From: Pederson Ronda M (AREVA NP INC) [Ronda.Pederson@areva.com]
Sent: Tuesday, October 20, 2009 6:46 PM
To: Tesfaye, Getachew
Cc: BENNETT Kathy A (OFR) (AREVA NP INC); DELANO Karen V (AREVA NP INC); VAN NOY Mark (EXT)
Subject: Response to U.S. EPR Design Certification Application RAI No. 215, FSAR Ch 3, Supplement 4
Attachments: RAI 215 Supplement 4 Response US EPR DC.pdf

From: Pederson Ronda M (AREVA NP INC)
Sent: Tuesday, September 29, 2009 6:54 PM
To: 'Tesfaye, Getachew'
Cc: BENNETT Kathy A (OFR) (AREVA NP INC); DELANO Karen V (AREVA NP INC); VAN NOY Mark (EXT)
Subject: Response to U.S. EPR Design Certification Application RAI No. 215, FSAR Ch 3, Supplement 3

QUESTIONS for Structural Engineering Branch 2 (ESBWR/ABWR Projects) (SEB2)

Question 03.07.01-23:**Follow-Up RAI to Question 03.07.01-15:**

Figure 03.07.01-23-1—General Trends in Transverse System Fundamental Frequency Based on Bechtel-ANCO Report Test Data for Various Manufacturers

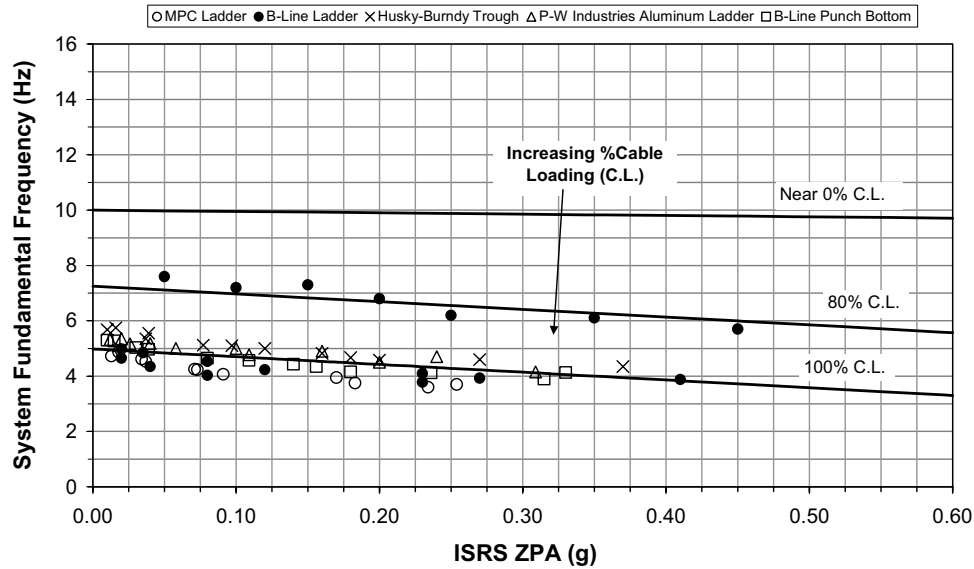
The response provided to **Question 03.07.01-15** refers to a proprietary report which provided the results of a test program that demonstrated that certain cable tray systems achieved damping values as high as 20 to 25 percent under dynamic loads. This report is the basis for allowing up to 20 percent damping for flexible supported cable tray systems. In reviewing a summary of the report, it appeared that for those systems achieving higher damping the response was nonlinear and could include yielding of the cable tray support system. The report also states that the resonant frequency of the cable tray system was dependent on the input level of the support excitation. Higher input levels resulted in lower resonant frequencies. Response spectrum analysis methods are often used for suspended systems and are based on an assumption of a linear response in the system being analyzed. The load applied to the system is a function of the system modal frequencies used in combination with a design response spectrum curve. It is not clear how the nonlinear behavior of the cable tray systems and dependence of natural frequencies on excitation level that were documented in the test report are applied in analysis methods that calculate the response of a system by linear elastic methods.

The markup to 3A.3.5 of the U.S. EPR FSAR appears to provide additional criteria for selecting damping values beyond what is specified in FSAR table 3.7.1-1 and states "The damping values [of] cable tray systems with less than 50 percent loading may be determined from Figure 3.7.1-16, which is dependent on the flexibility of the cable tray system, including both the cable tray and its supports for an input ground motion ZPA up to and exceeding 0.35g." However, if Figure 3.7.1-16 is dependent on the flexibility of the cable tray system, it does not provide any additional guidance or limitation on its use in this regard.

In its markup of the FSAR the applicant has added a note to Table 3.7.1-1 that limits the use of higher damping values to flexibly supported rod and strut-hung trapeze systems, and strut-type cantilever and braced-cantilever cable tray systems loaded to greater than 50 percent of the maximum rated loading. The staff believes the information provided is insufficient to support the use of higher damping values in seismic Category I cable tray systems with flexible supports. To justify the higher damping, the applicant needs to submit on a case-by-case basis the following information:

Results of the Bechtel-ANCO report showed that system fundamental frequency of cable tray systems for all percentages of fill is dependent on the input level of support excitation and that higher input levels tend to result in slightly lower system fundamental frequencies. This degradation in system fundamental frequency, which is linear with respect to input acceleration (in-structure response spectrum (ISRS) zero-period acceleration (ZPA)), is attributable to higher intensities of friction between cables and movement and bouncing of cables within the tray as input acceleration increases, and was only observed after a significant number of loading cycles. Figure 03.07.01-23-1 includes a list of manufacturers and shows transverse system fundamental frequency trends for typical cable trays with strut trapeze-type supports and transverse bracing. System fundamental frequency is observed to decrease monotonically as a function of ISRS ZPA, with the rate of decrease dependent on cable loading. The offset between the trend curves illustrated in Figure 03.07.01-23-1 is caused by change in cable mass. These results, shown with the frequency axis non-dimensionalized in Figure 03.07.01-23-2, indicate that acceleration dependent system fundamental frequencies can be determined from the calculated static (i.e., ZPA) system fundamental frequency by applying an adjustment in accordance with the trend curves.

Figure 03.07.01-23-1 shows analytical and computer models that were developed and calibrated to evaluate the cable tray systems that were experimentally tested. These models are used to predict the system fundamental frequency of the experimentally tested systems for the case of low acceleration within reasonable accuracy. For design purposes, the system fundamental frequencies at ZPA can be used to determine the system fundamental frequencies at higher acceleration input by using the trend lines shown in Figure 03.07.01-23-2, which are based on experimental test data. The acceleration used to make the correction is the ISRS ZPA corresponding to the location where the cable tray is to be mounted. When the trend line correction is applied, the system fundamental frequency is bracketed by ± 20 percent to account for modeling uncertainties. Response spectrum methods can then be used to obtain the response of the cable tray system based on the highest acceleration within the bracketed system fundamental frequency bandwidth.

Figure 03.07.01-24-1—Comparison of Input Motion for Structures Not on the NI Common Basemat and the Minimum Required Spectrum, Horizontal Motion 5% Damping

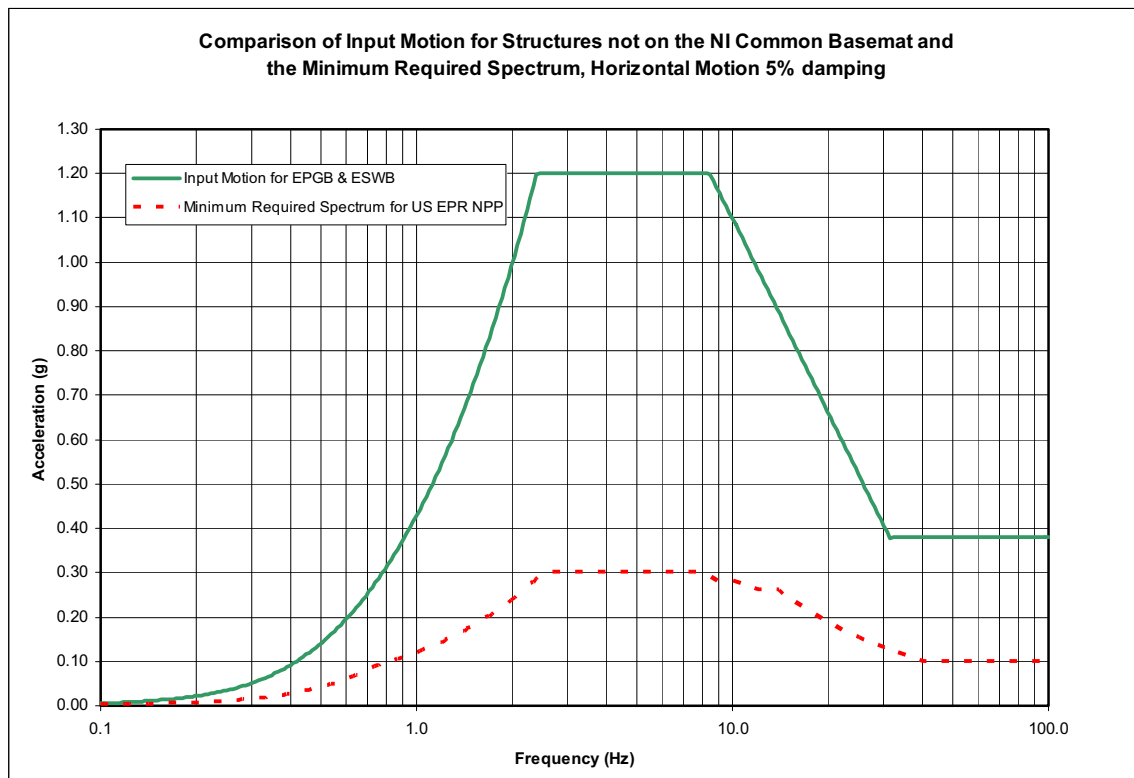
To meet the regulation requirements of Appendix S of 10 CFR Part 50, the applicant is requested to provide in the U.S. EPR FSAR the response spectra used to meet the minimum horizontal response spectra required in the free field at the foundation levels of the EPGB and ESWB structures.

Input motion for Emergency Power Generating Building (EPGB) and Essential Service Water Building (ESWB) in terms of 5 percent damped acceleration response spectrum is provided in Figure 03.07.01-24-1. As discussed in U.S. EPR FSAR Tier 2, Section 3.7.1.1.1, this motion is the certified seismic design response spectra (CSDRS), envelope of European utility requirement (EUR) spectra anchored to 0.3 g, plus structure-to-structure amplification from NI common basemat. Comparison in Figure 03.07.01-24-1 shows that input motion for EPGB and ESWB at the foundation levels envelop the appropriate design spectrum for U.S. EPR, which is discussed in U.S. EPR FSAR Tier 2, Section 3.7.1.1.1 and shown in U.S. EPR FSAR Tier 2, Figure 3.7.1-2. Thus, it also meets 10 CFR 50, Appendix S minimum horizontal response spectrum requirement.

Figure 3.7.1-16—Damping Values for Cable Tray Systems

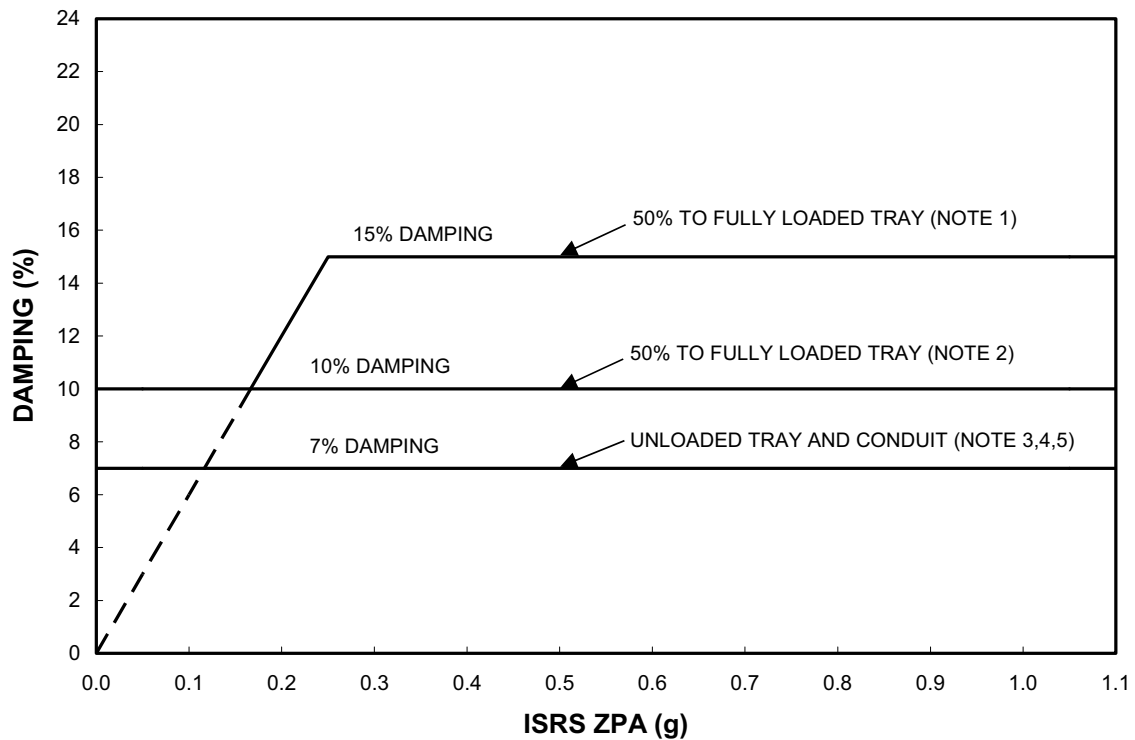
- b. The method of analysis, how natural frequencies are determined, how the loads are determined, and the ratio of actual demand in the cable tray system and loads in the anchors to the code allowables;
- c. The design methods and design procedures that are used to implement the test results from the ANCO report;
- d. A correlation and applicability of the cable tray configuration (support system, percent filled, use of ties, anchor system, etc.) to the test configurations and results from the ANCO test report; and
- e. The technical basis for Figure 3.7.1-16 and how the flexibility of the cable tray system is accounted for in the use of this figure and what configurations are covered under the definition of a flexible support system.

loaded, damping ratios of up to 15 percent will be used in accordance with curve 2 in Figure 03.07.01-23-3. Note that this is even more conservative than the original curve proposed from findings in the Bechtel-ANCO report, which was shown to be a lower bound of the experimental data. The additional conservative measures as described above will be implemented by modifying U.S. EPR FSAR Figure 3.7.1-16 to reflect curve 2 in Figure 03.07.01-23-3.

Based on findings from the Bechtel-ANCO report, the statement in U.S. EPR FSAR Tier 2, Section 3A.3.5 that U.S. EPR FSAR Tier 2, Figure 3.7.1-16 is “dependent on the flexibility of the cable tray system” will be revised. For an ISRS ZPA greater than 0.25 g, a damping ratio of at least 15 percent is provided for flexibly supported cable tray and for rigidly mounted cable tray, and thus the 15 percent has no dependence on support flexibility. U.S. EPR FSAR Tier 2, Section 3A.3.5 will be revised by removing this statement.

- e) The technical basis for U.S. EPR FSAR Tier 2, Figure 3.7.1-16 was addressed in a previous section of this response, wherein Figure 03.07.01-23-3 of this response was discussed. U.S. EPR FSAR Tier 2, Figure 3.7.1-16 is not dependent on the flexibility of the cable tray system. A damping ratio of at least 15 percent has been demonstrated for both flexibly supported cable trays and for rigidly mounted cable trays, and thus the damping ratio is not dependent on support conditions. The statement in U.S. EPR FSAR Section 3A.3.5 regarding the dependence of U.S. EPR FSAR Figure 3.7.1-16 on the flexibility of the cable tray system will be corrected.
